Amendments to the Drawings

Remarks

Objections to the Drawings

FIG. 1

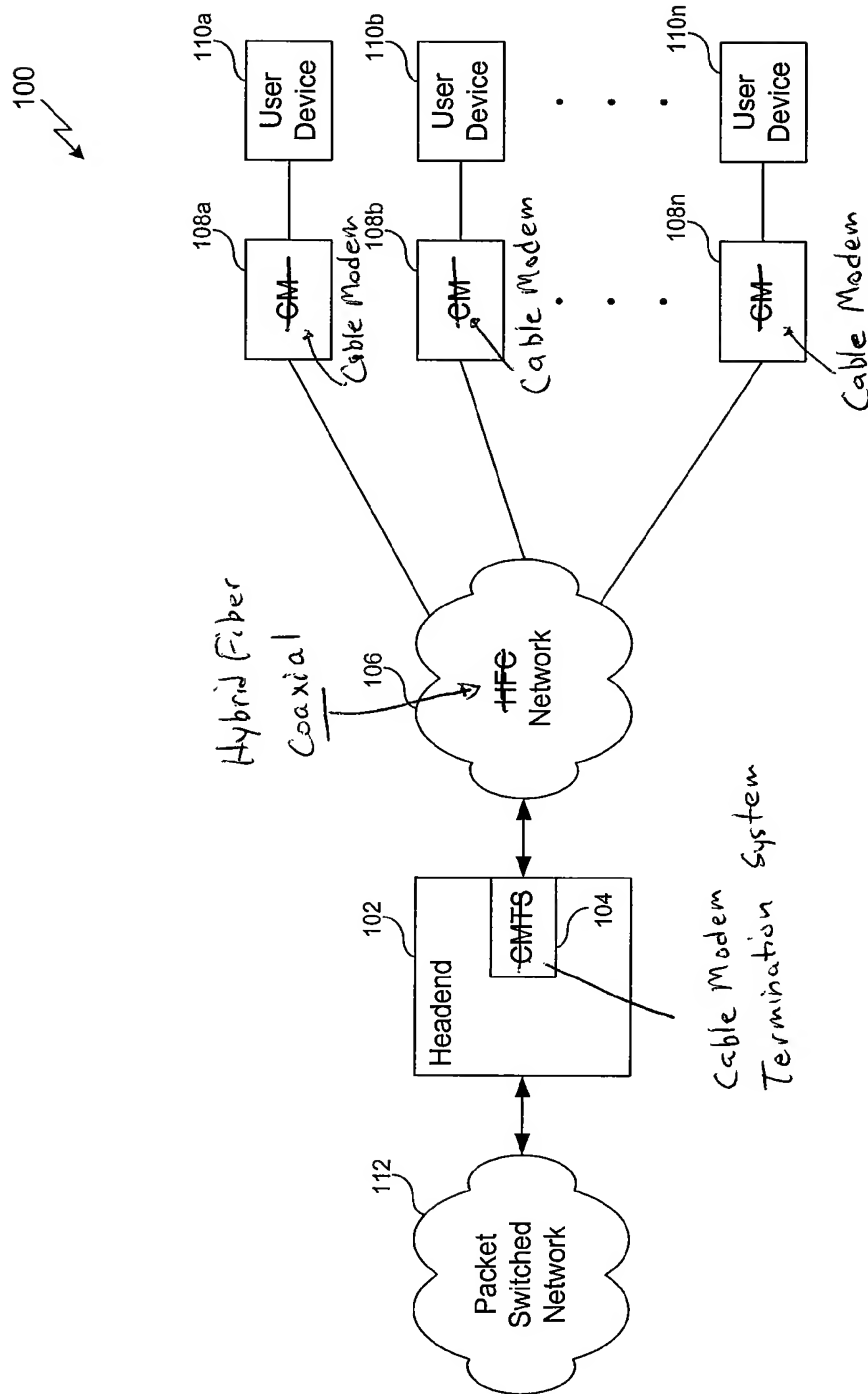
The attached sheets of drawings include changes to FIGs. 1, 2, and 4A-4C. These sheets replace the original sheets including FIGs. 1, 2, and 4A-4C. In FIGs. 1, 2, and 4A-4C, undefined acronyms have been removed in response to the Examiner's objections. FIG. 4C has also been amended to correct a clerical error.

On page 2, the Examiner objected to the drawings because FIGs. 1, 2, 4A and 4C do not have a descriptive legend of the acronyms CMTS, HFC, CM, SDRAM, and NCO. Although suitable legends “may be required by the Examiner where necessary for understanding of the drawing” (37 C.F.R. § 1.84), Applicants respectfully disagree with the Examiner’s position with regard to the particular legends referred to in the action.

CMTS (104): “The cable headend 102 includes at least one cable modem termination system (CMTS) 104.” (paragraph [0027]).

HFC Network (106): “. . . via a communications network 106, which, by way of example, may comprise a hybrid fiber coaxial (HFC) cable network..” (paragraph [0027]).

CM (108a-n): “. . . and a plurality of cable modems (CM) 108a-108n” (paragraph [0027]).

However, in the interest of expediting prosecution, Applicants have amended the drawings to overcome the Examiner’s objections, with the exception of “SDRAM.” Support for the amendments may be found, *inter alia*, at the aforementioned paragraphs defining the acronyms. Applicants have not defined the term SDRAM in the figures (in addition to the aforementioned definition in the specification) since this term is well known in the art.
